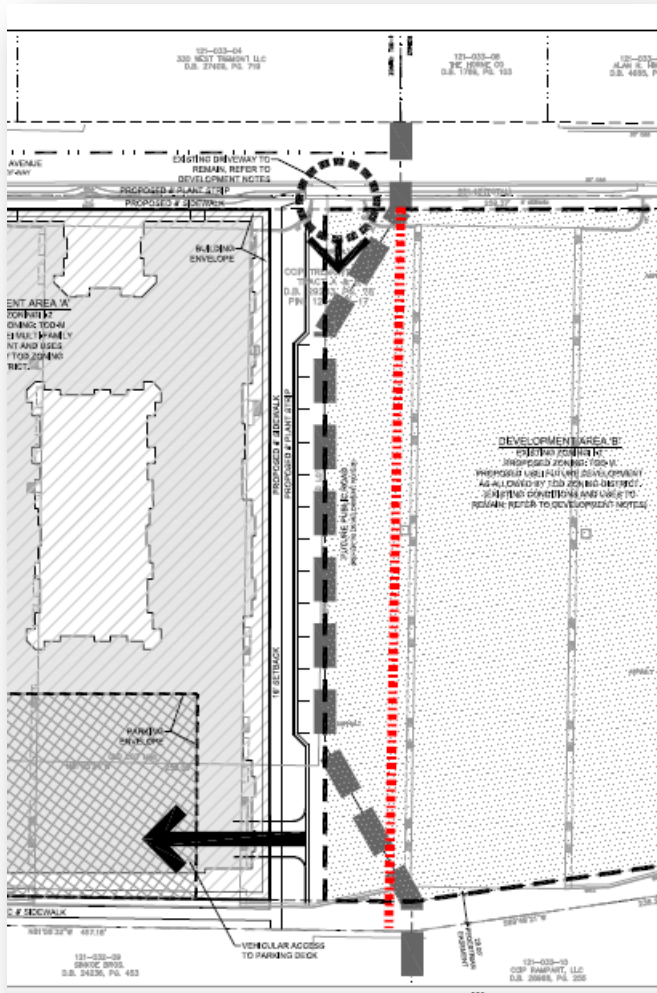
1. CDOT requests that the proposed half street alignment be re-designed to align with the existing half street that currently exists on the other side of W. Tremont Ave. Please see below:

CDOT would be willing to explore a second option with the petitioner which would allow this development to maintain the existing driveway location to serve the parking deck on a temporary basis (without constructing the half street at this time) until such time that the existing building in

Development Area "B" is torn down and redeveloped. At that time the necessary right of way will be dedicated and the entire cross section of the roadway shall be constructed.
